**UNITED STATES ENVIRONMENTAL PROTECTION AGENCY**  
**REGION IX**  
**75 Hawthorne Street**  
**San Francisco, California 94105**

**EPA Review of the June 15, 2018, Draft *Parcel G Removal Site Evaluation Work Plan*,  
Hunters Point Naval Shipyard, San Francisco, California  
EPA Review dated August 14, 2018**

SUBJECT: FINAL - STATISTICAL REVIEW OF UNITED STATES NAVY DRAFT PARCEL G REMOVAL SITE EVALUATION WORK PLAN, HUNTERS POINT NAVAL SHIPYARD SITE (HPNS), SERAS-106, WORK ORDER #83

Figure 1. Distribution of Ra-226 Off-Site Laboratory Measurements in picocuries per gram (pCi/g) in Background Reference Areas

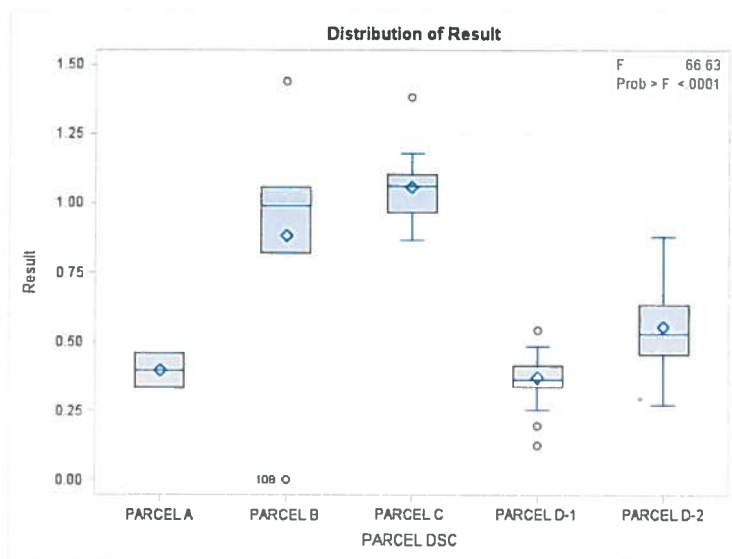
A similar evaluation must be made prior to combining surface and subsurface sample results. Appendix A of the Work Plan acknowledges the expected disparity between the RBAs and states on page 3-1 *"Collections of fallout radionuclides are variable in soil at HPNS because of deposition and erosion, and from layering and mixing during placement of fill soil. Thus the concentrations of naturally occurring ubiquitous radionuclides may vary by location and depth."* It is unclear at this time, whether stratification of the soil in Parcel G also includes stratification of ROC concentrations within the RBAs, and if combining surface and subsurface sampling results within the individual RBAs or across the combined RBAs is appropriate for comparison to the soils in the TUS and SUs.

**Discussion:** Unless and until evidentiary data is collected to demonstrate that sample results from the four on-site RBAs can be combined to represent one reference background population, sufficient and an equal number of samples should be collected per RBA and per soil depth (surface and sub-surface) to allow for independent comparisons with on-site data. It is already noted in the Naval Draft Work Plan that the Bayview Area represents a different distribution of ROCs than the four on-site areas. Twenty-five surface soil samples are planned for collection at the Bayview Area; an equal number should be collected from the on-site RBA's.
